2202 8th Avenue  
Design Review Board

DPD PROJECT NUMBER: 3016464

Recommendation Meeting: 04.November 2014

## Design Review Board Comment Responses

## A2 - Enhance the Skyline

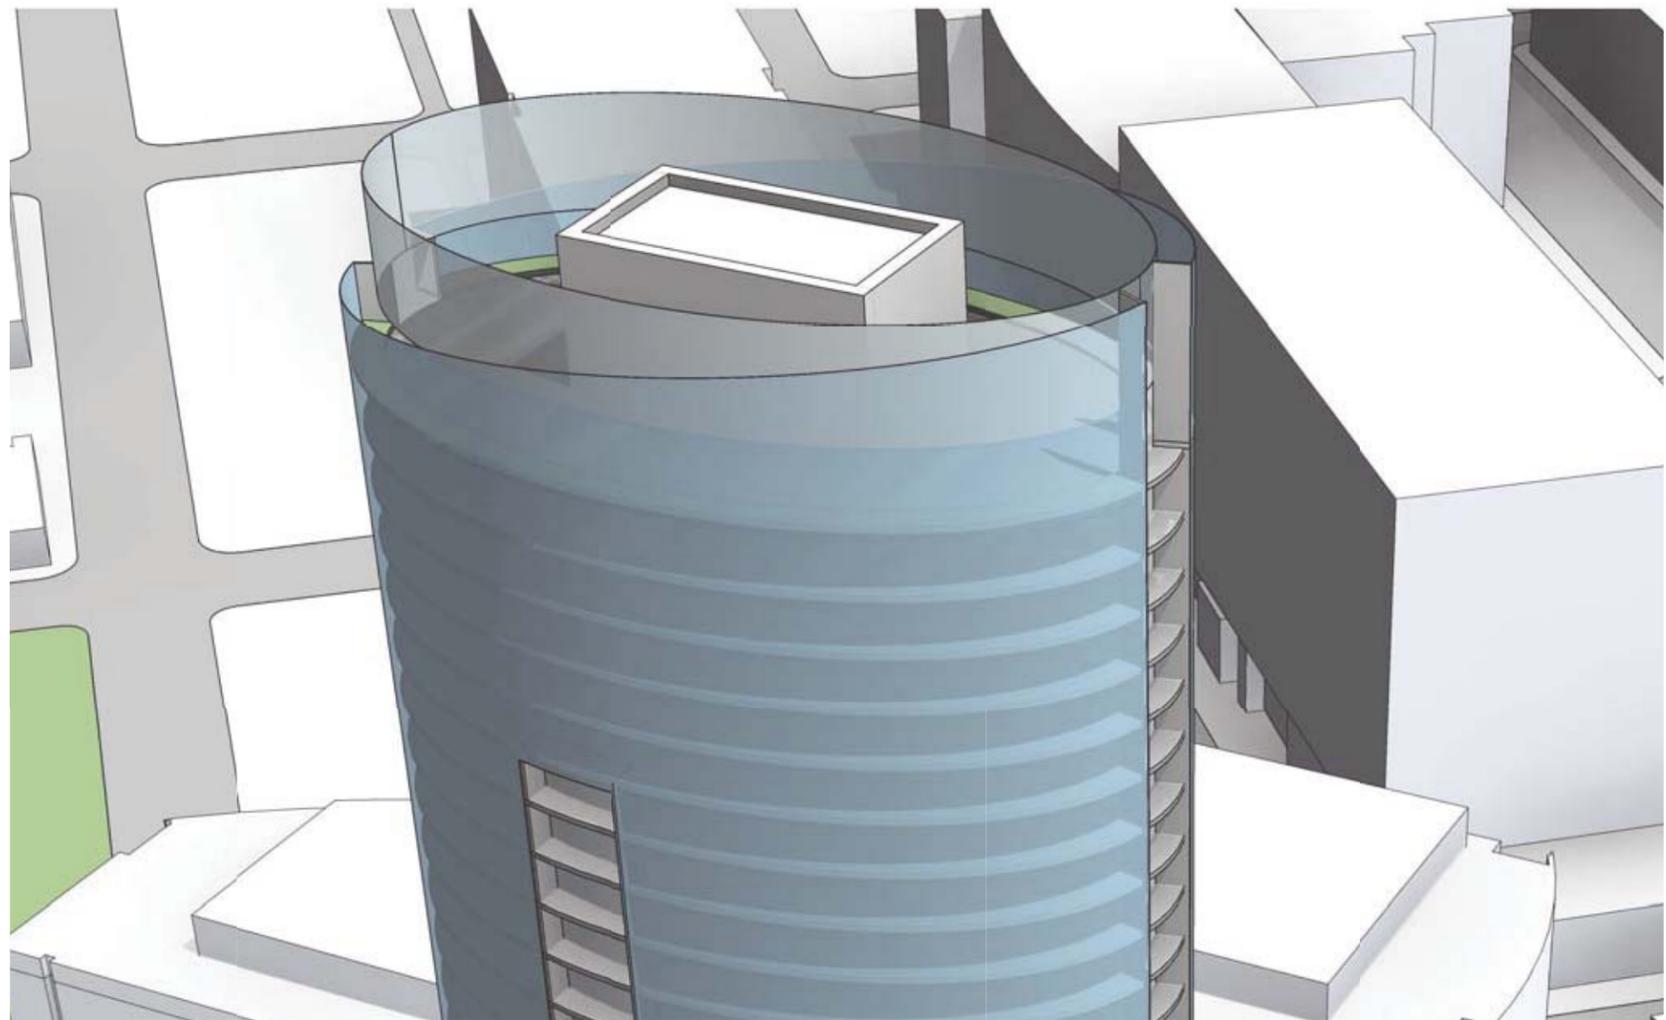
1. Supported preliminary roof design:
  - a. Layered and tapered screens.
  - b. Better residential scale than pure extrusion.
  - c. Gracious transition to sky.
2. Suggestion(s) for refinement:
  - a. Consider using vegetation and a sophisticated, restrained lighting design that incorporates the tall screen.

Roof screen lighting concept

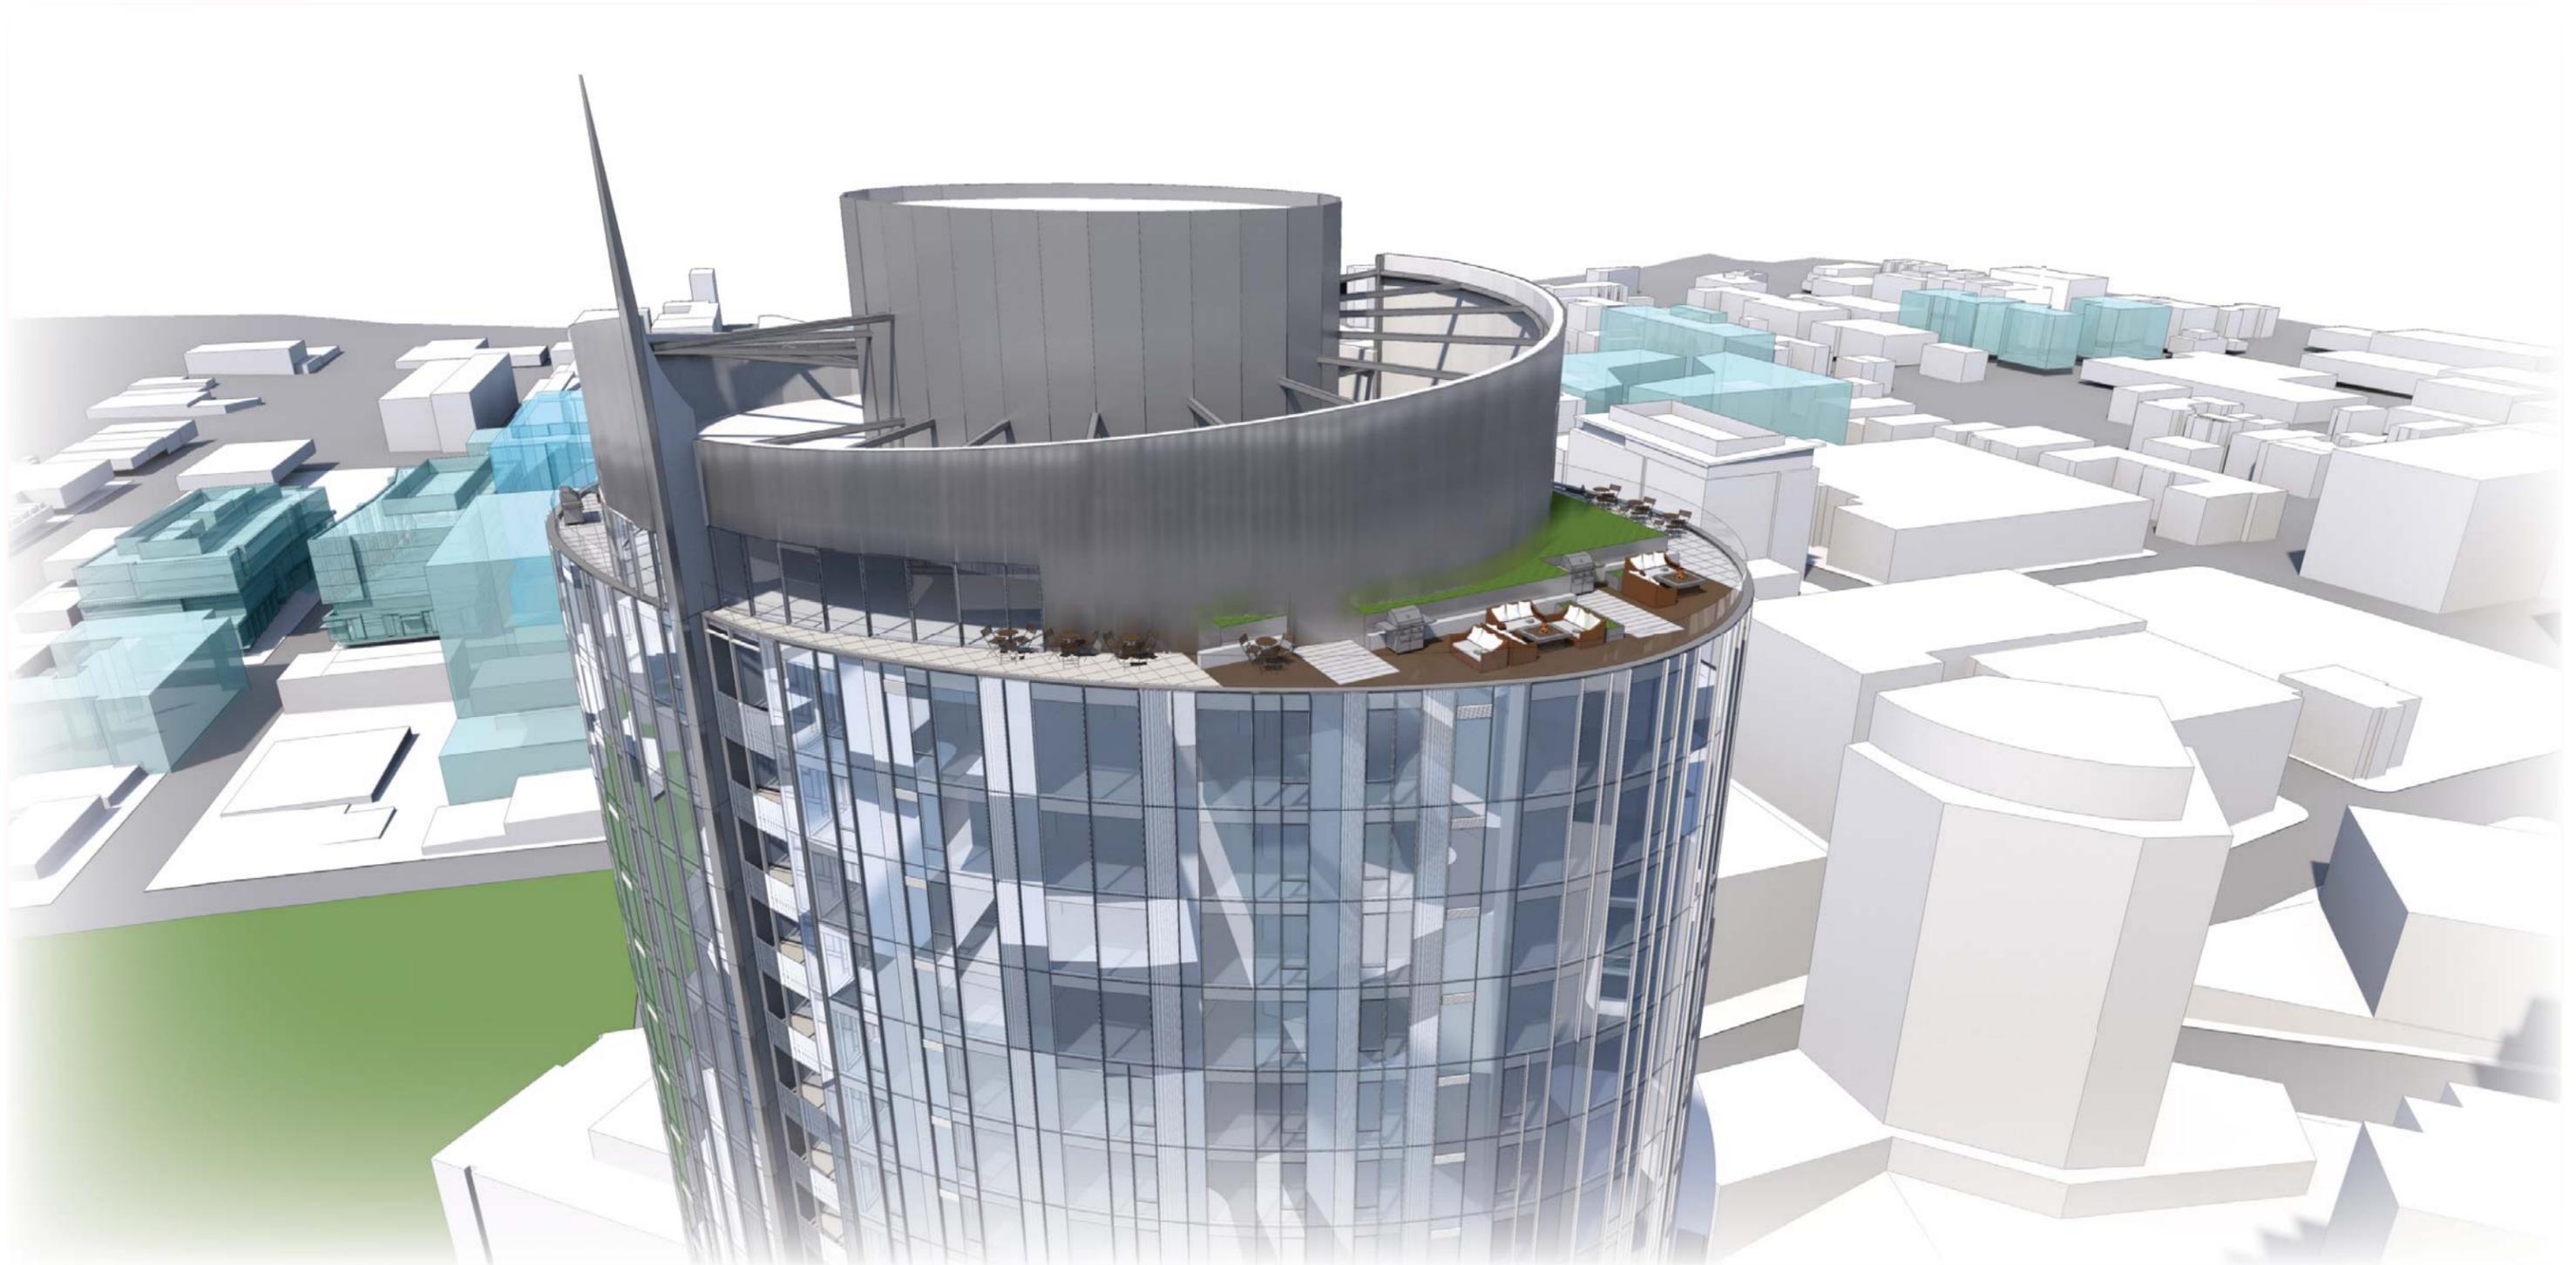
1. The board supported preliminary roof design:
  - a. Layered and tapered screens.
  - b. Better residential scale than pure extrusion.
  - c. Gracious transition to sky.

2. Suggestion(s) for refinement:
  - a. Consider using vegetation and a sophisticated, restrained lighting design that incorporates the tall screen.

The lighting and materiality will reinforce the verticality of the project while creating visual cues that can be experienced both from afar and close up.

Detailed Shadow Study

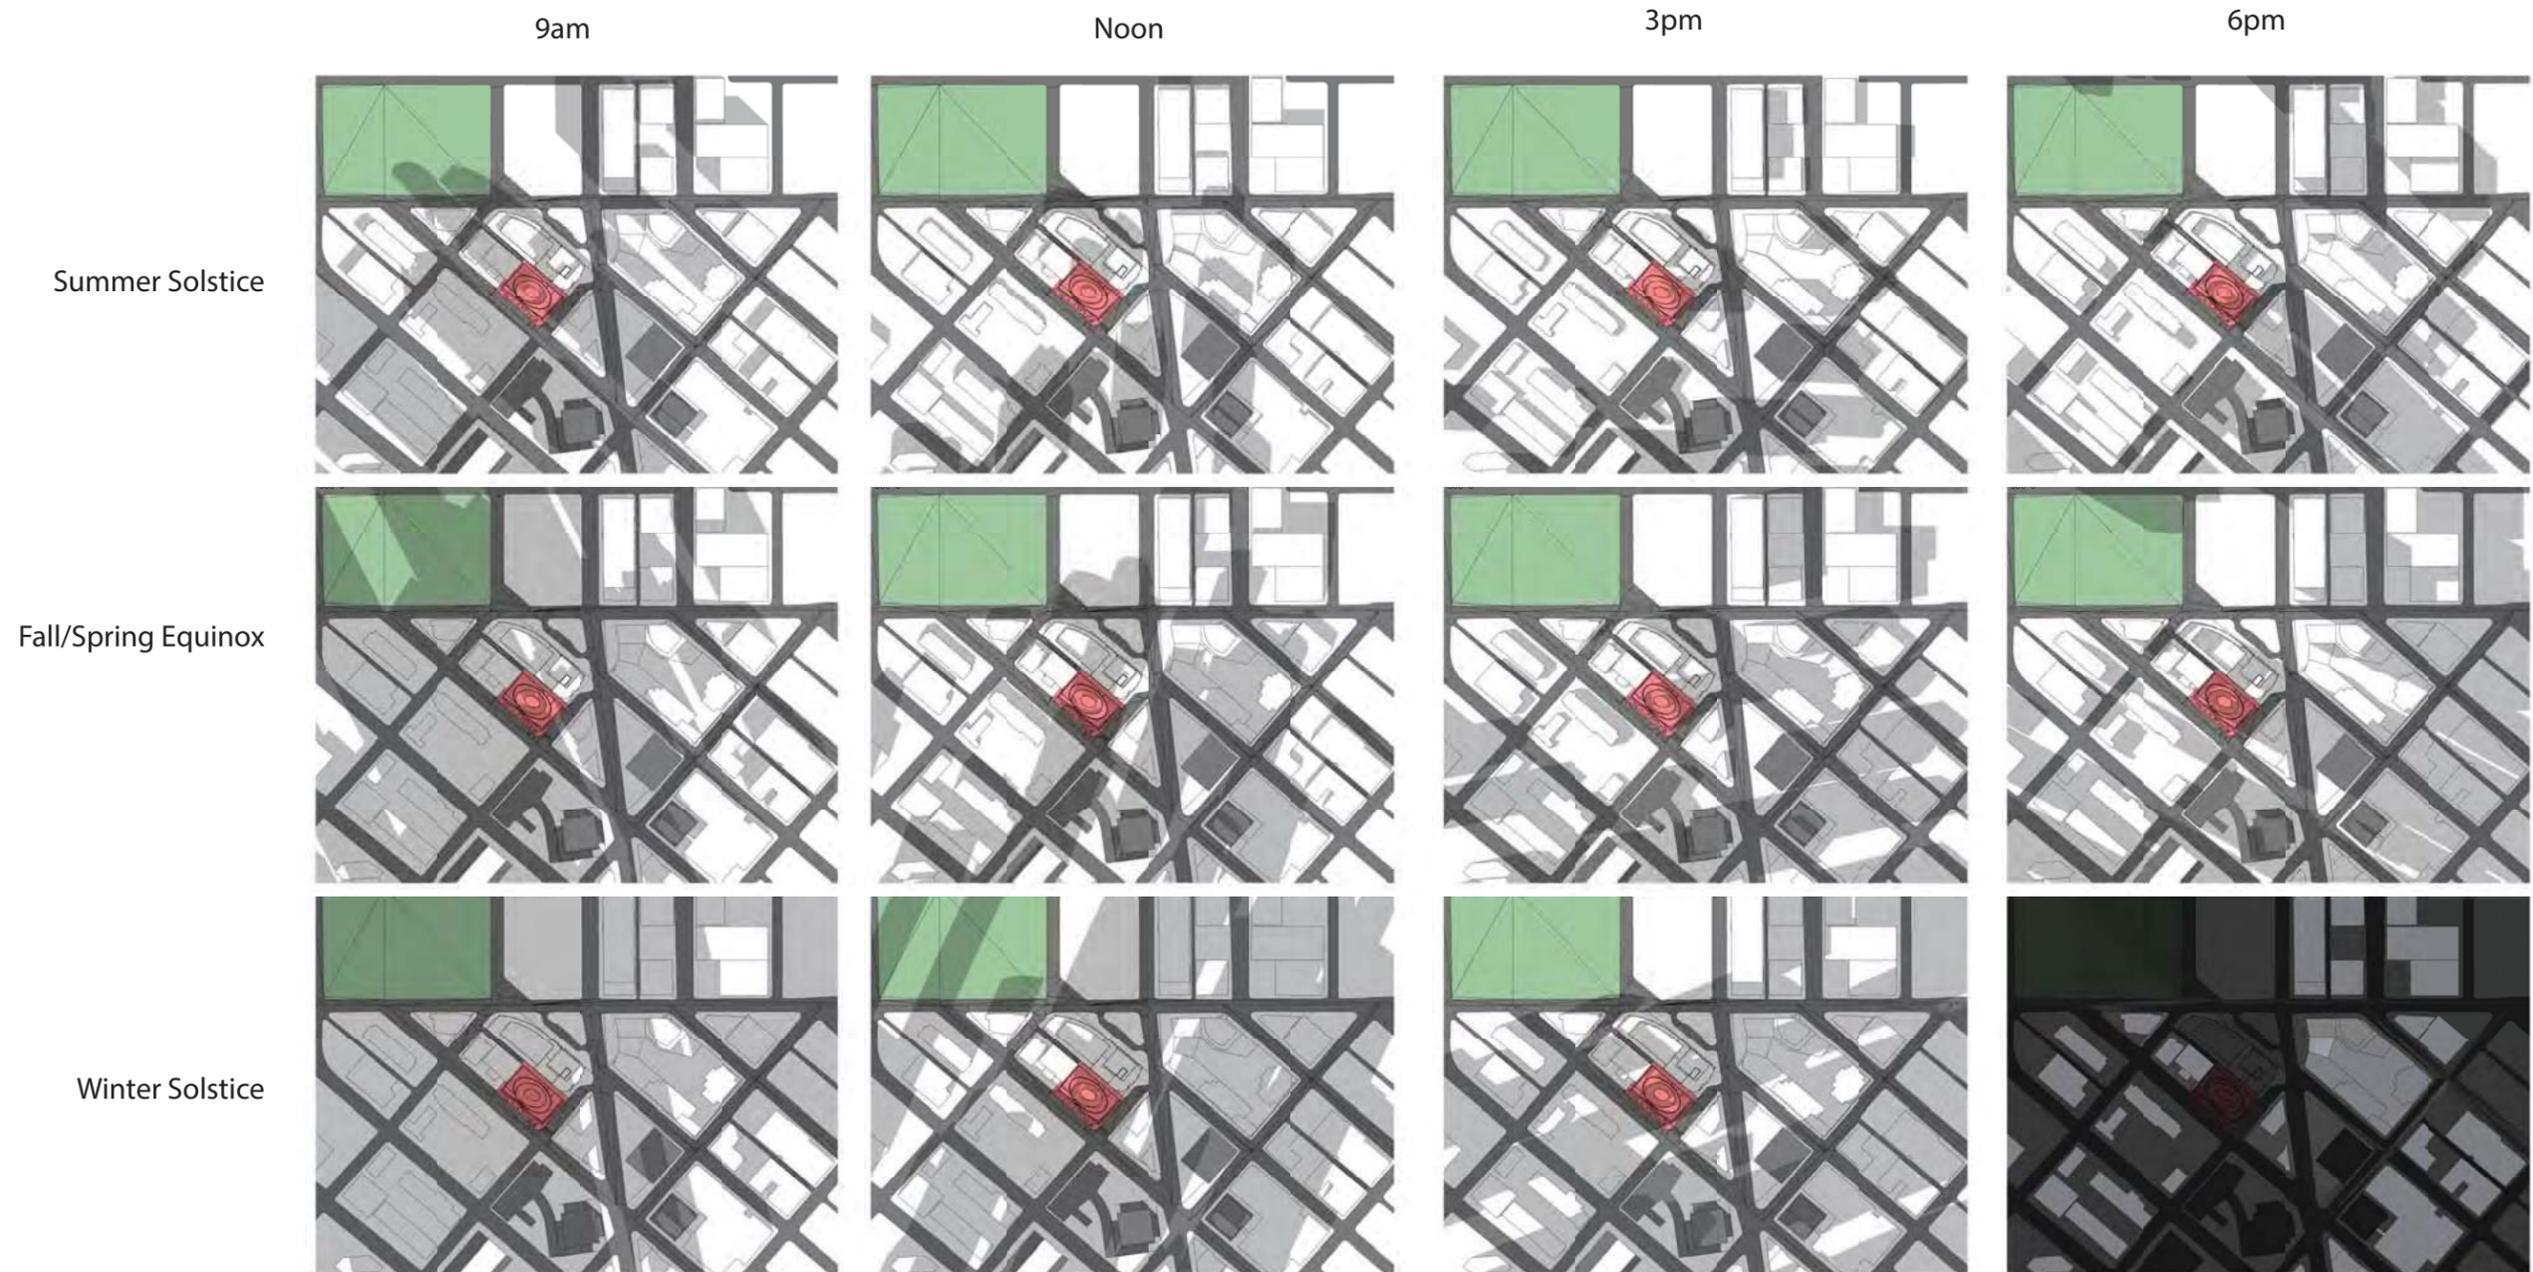
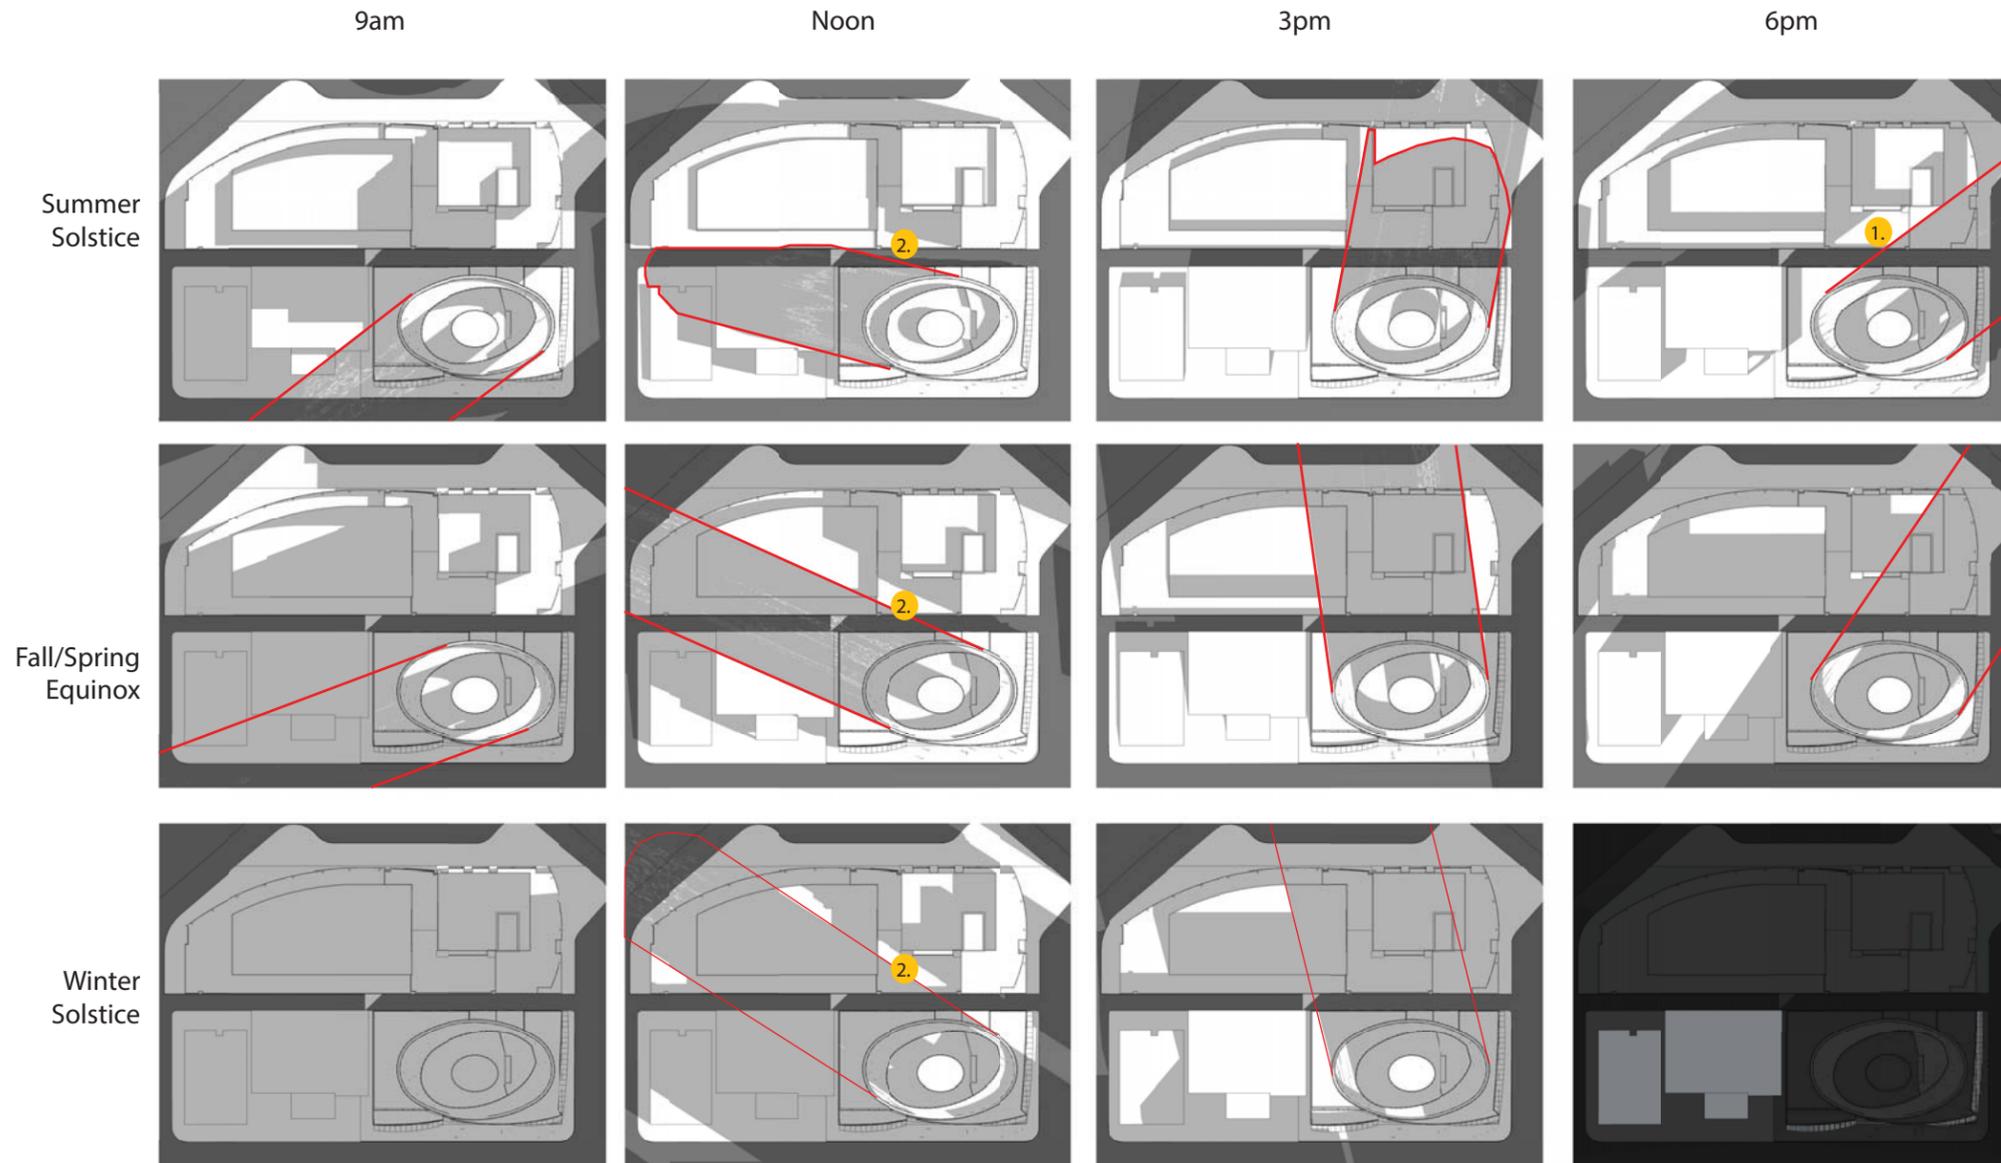
1. Glass and material composition should be studied carefully at Enso facing facades for privacy and reflected winter light.(See Responses for C6 alley facade design)
2. Asked for:
  - a. Zoomed in shadow studies with full range of times and dates.

1. The building's elliptical shape allows afternoon and evening sun to get to the adjacent Enso amenity deck during the summer months
2. The building's elliptical shape allows sun to get to the adjacent Enso amenity at mid day throughout the year
